# SERVICE BULLETIN

No. 488

Piper Aircraft Corporation

Modification of Landing Gear Selector Cable Forward Attachment Pin.

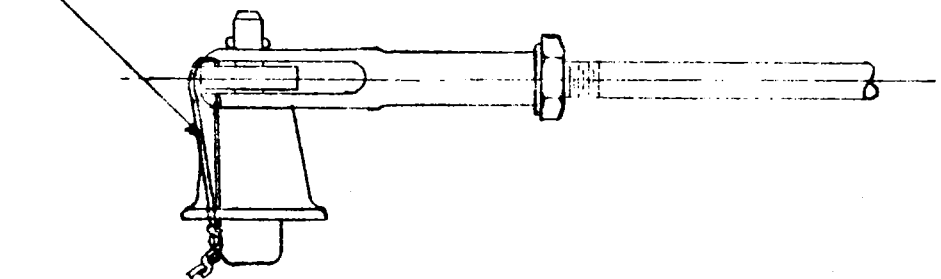
5. Safety with approximately three inches of MS20995C41 lock wire (.041 stainless steel) through the hole in the arm and existing hole in pin knob per attached sketch.

Wrap lock wire around arm on side opposite from cable, to prevent interference with cable clevis during normal operation.
